READING VILLAGE ARCHITECTURAL PEER REVIEW PHASE 2

Report by:
TBA Architects, Inc.
43 Bradford St. Suite 300
Concord, MA 01742
P: (781) 893-5828

Submitted to the Town of Reading on July 15th, 2016 rev. July 20, 2016

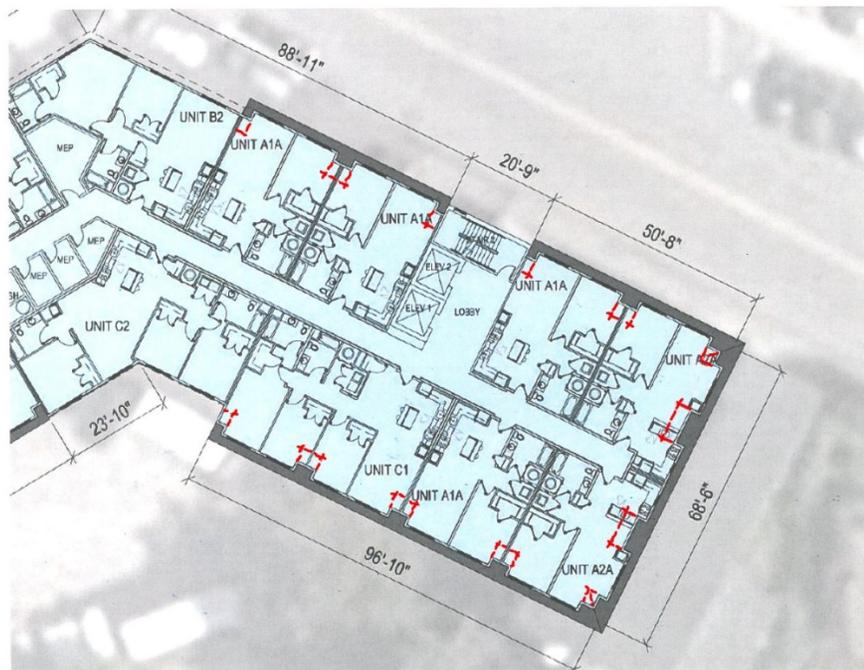
- i. The corner parcel has been included in the project which decreased the scale from the previous submission, which is an improvement given the scale of the community and neighborhood.
- ii. The South/Southwest elevations facing the "rear" of the lot is shown on the "Perspective facing North" which provides additional detail on the building and its relationship to the abutting houses on Washington Street. We find this view to be somewhat misleading, in that the building appears fully set in green space.

While neighbors' yards and large existing trees will frame the view of the building, the proposed landscaping, driveway and parking is not shown. Also, the lower level appears open to the windows at grade on Prescott Street. These would likely be obstructed by parked cars.

- i. Clarify the vehicular clearance to the parking area and provide revised building elevations if the first floor level is revised.
- ii. Revise back elevation perspective to include proposed parking lot, cars, driveway, and proposed planting/screening.
- iii. Update the top floor to include ceiling heights and show where ceiling heights change.
- iv. Consider revising top floor unit configurations to accommodate usable ceiling heights.
